Engineering Assessment Report

Cherry Orchard Point – Phase 2 of Proposed Development at Sites 4 and 5, Park West Avenue, Dublin 10

Client Name: Dublin City Council in partnership with the Land Development Agency
Document Reference: 22-010r.024 Phase 2 Engineering Assessment Report
Project Number: 22-010

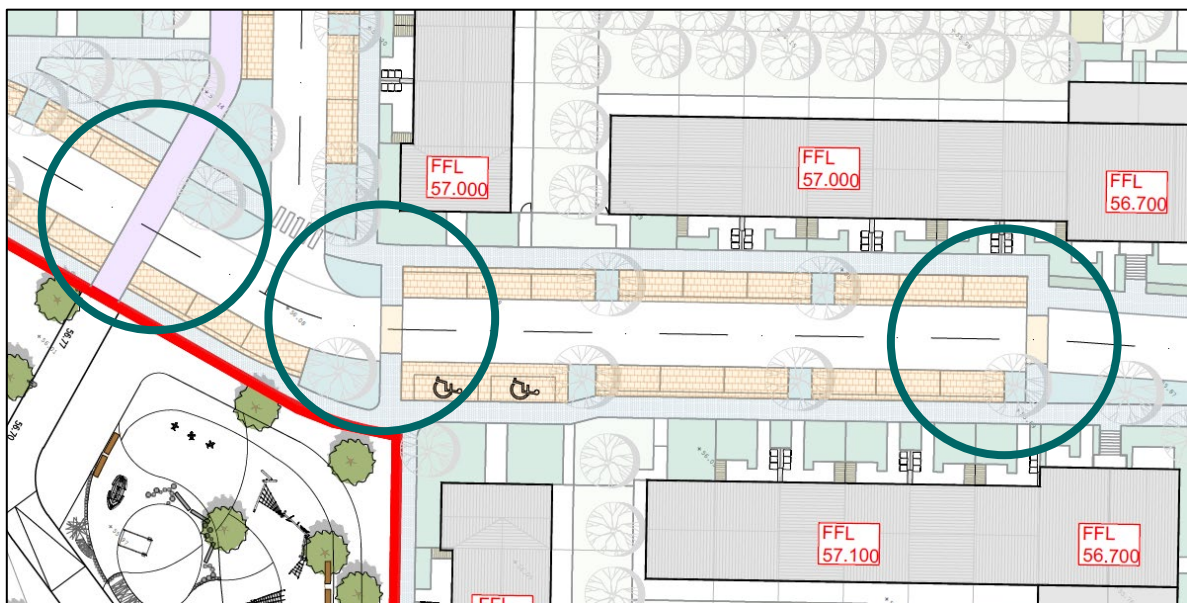
There are a number of locations where buildouts project into the carriageway resulting in pinch points. This can lead to side swipe collisions. In addition, in the absence of appropriate edge guidance, there is a risk of vehicles colliding with the buildout.

Review the carriageway layout and provide adequate street space to cater the needs of all road users.

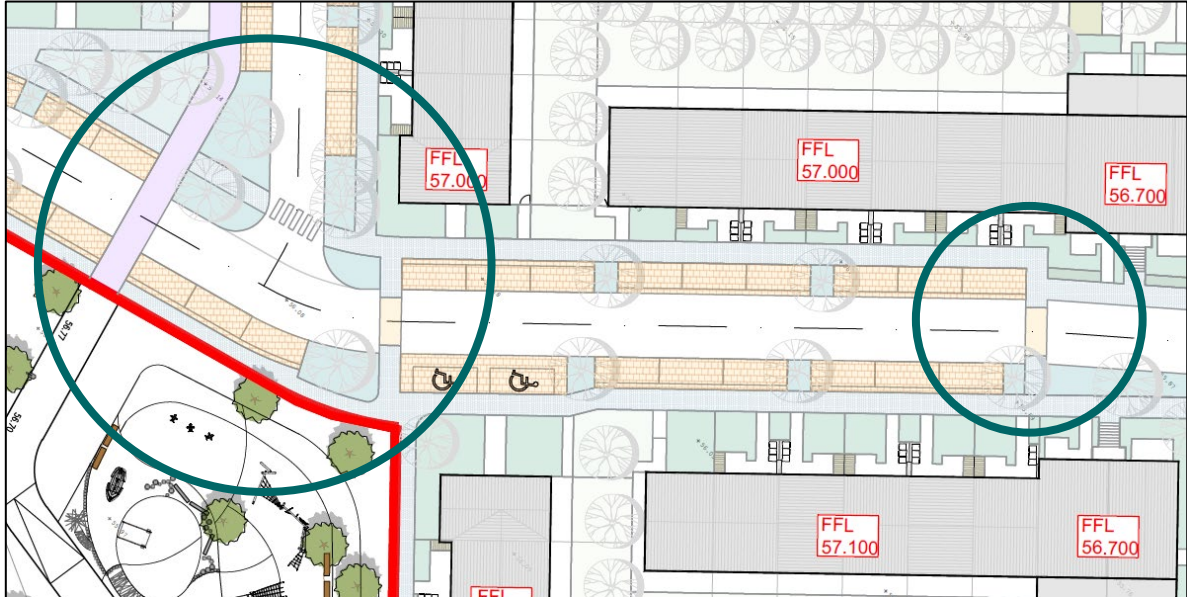
At a number of locations, pedestrian crossings are shown to be provided within the development without adequate crossing features indicating priority. Such a layout may confuse both motorists and pedestrians as to who has priority at the crossing which could contribute to a pedestrian collision at these locations.

2.11 Problem: Inadequate Pedestrian Crossing Features**Location:** In the Development

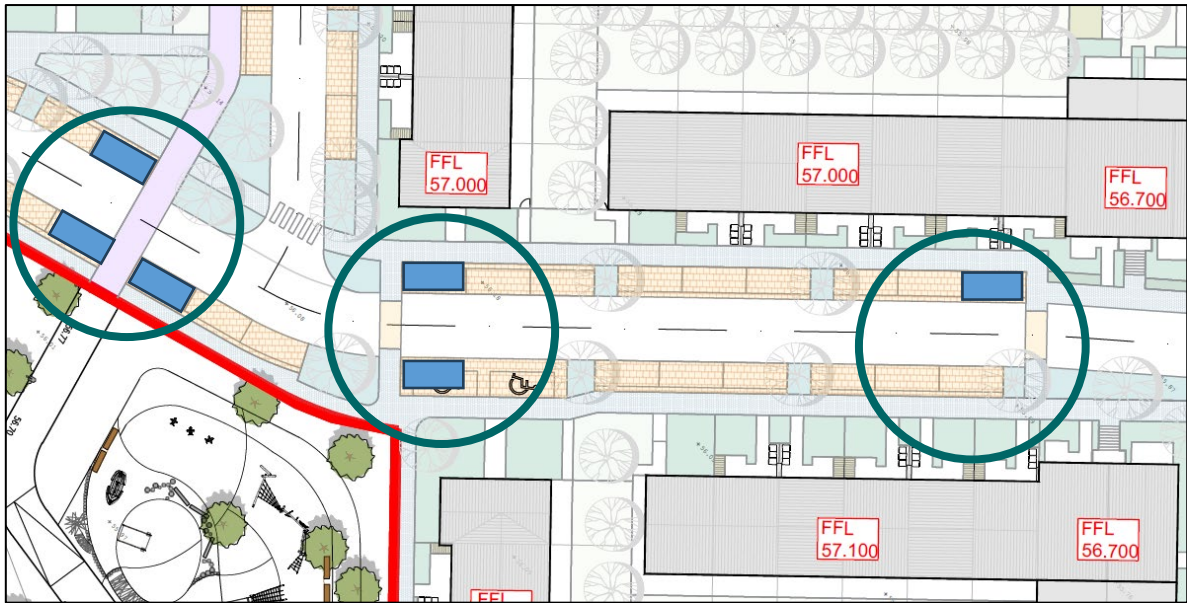
Facilities such as dropped kerbs and tactile paving are not shown to be provided for pedestrians at proposed pedestrian crossings. This may cause difficulty or delay for crossing movements by pedestrians and increase the risk of their being struck by passing motor traffic.

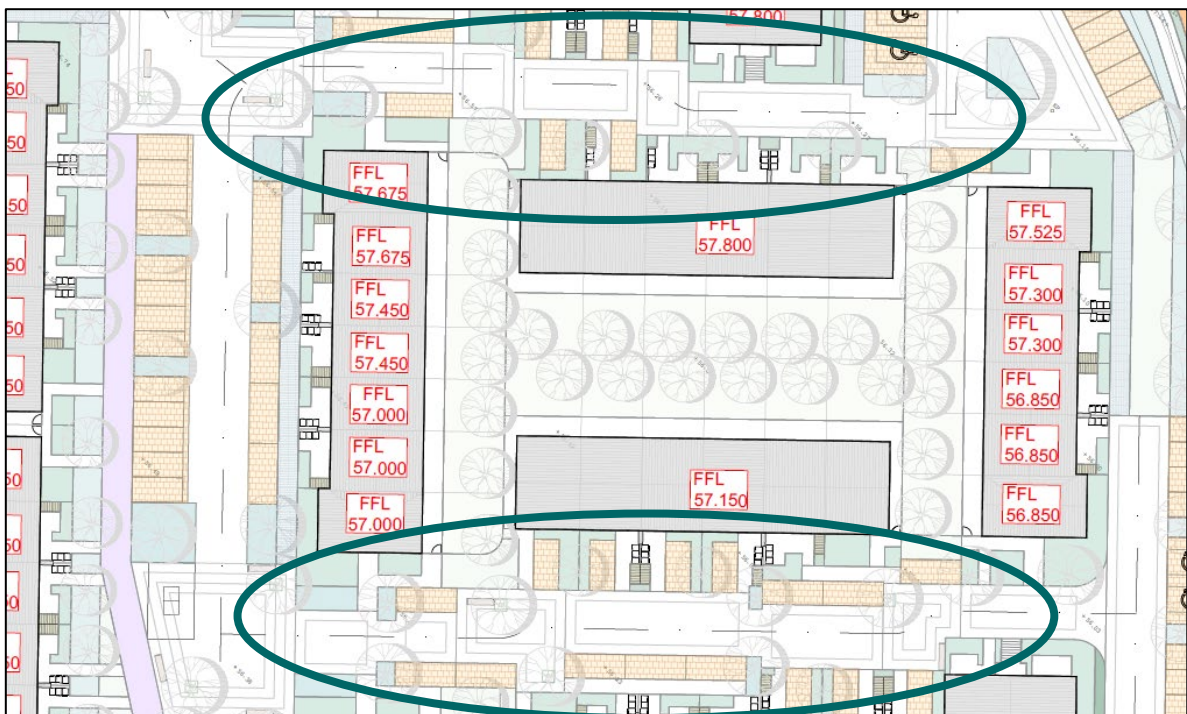
Intervisibility between pedestrians crossing pedestrian crossings at the locations shown below and drivers of vehicles approaching the crossings may be restricted by parked cars adjacent to the crossing. A lack of adequate intervisibility may contribute to a collision at these locations.

Ensure adequate intervisibility is provided between pedestrians and drivers of vehicles approaching all pedestrian crossing locations.

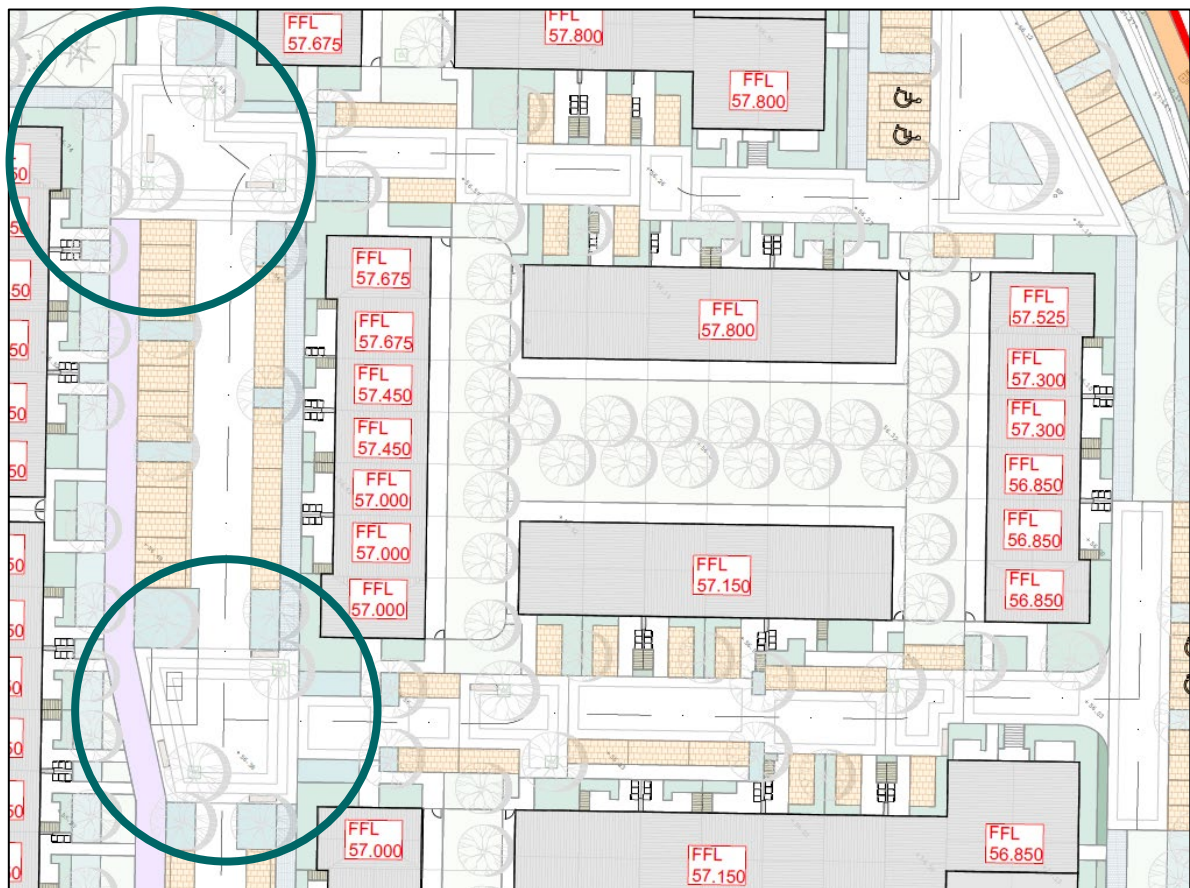
The east west access roads have an inconsistent width, and there are a number of locations where the alignment appears to be confusing to the road users and could increase the risk of collisions at these locations.

The east west access roads should have a consistent width and smooth alignment to minimise potential conflict for road users.

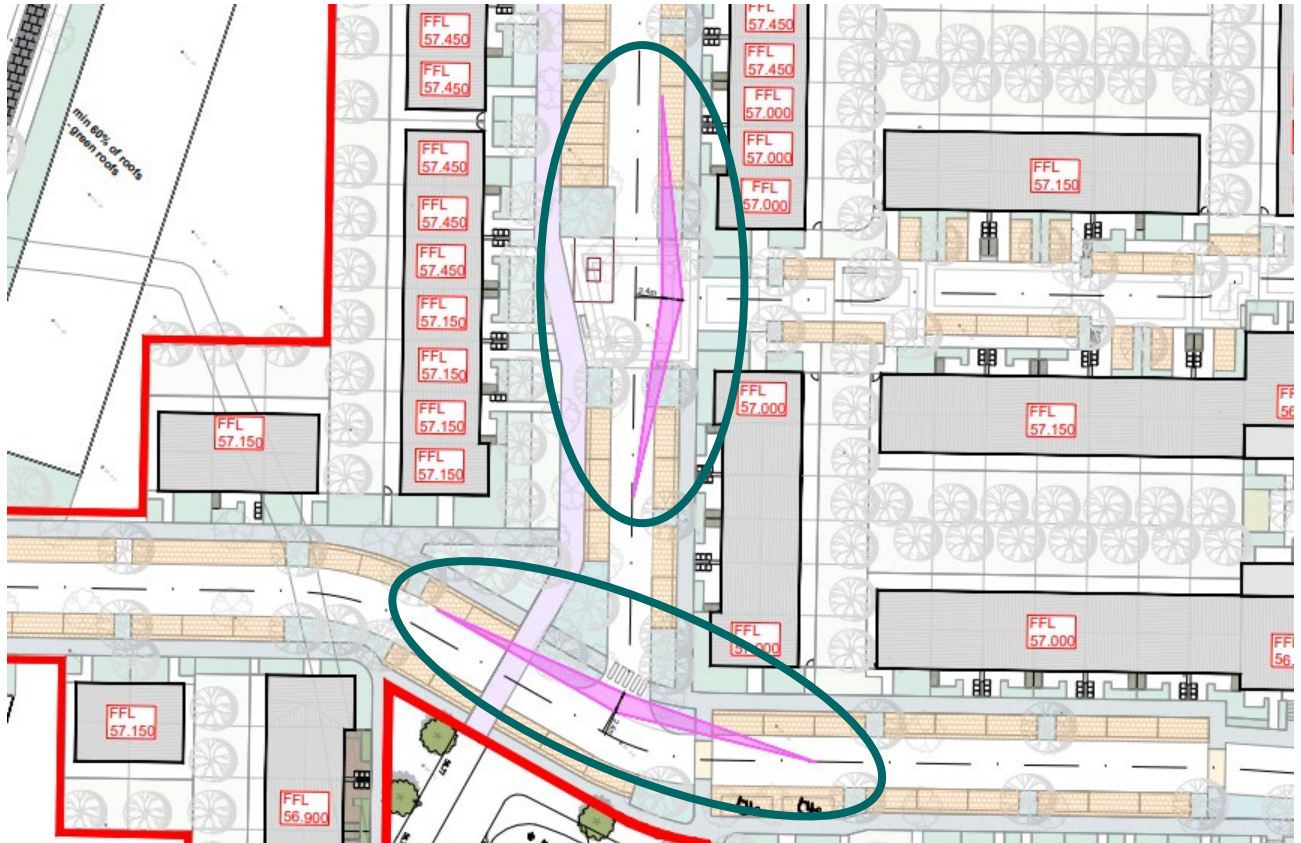
The layout and priority at some junctions appears to be confusing to road users at a number of locations which could contribute to pedestrian collisions and vehicle collisions at these locations.

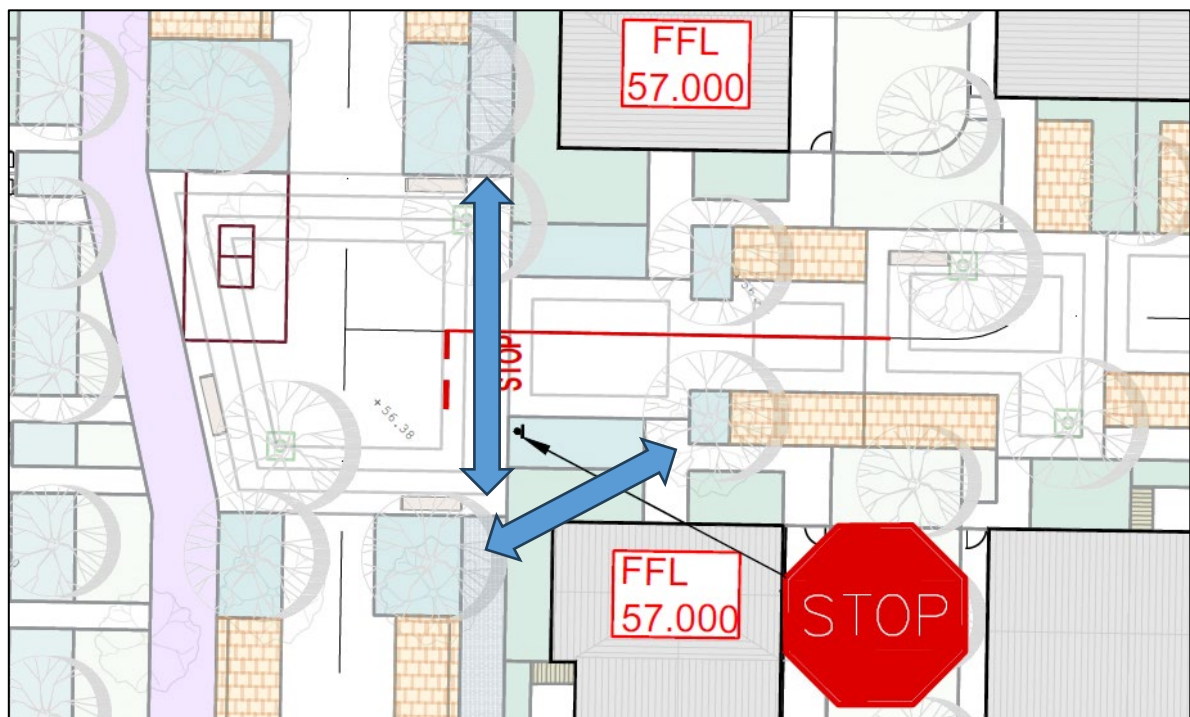
The footpath widths appear to be insufficient to accommodate mobility impaired pedestrians at a number of locations. This may result in pedestrians travelling along the carriageway where they would be at an increased risk of being struck by a passing vehicle, or into adjacent landscaping causing injury.

Ensure that adequate footpath widths are provided throughout the proposed development.
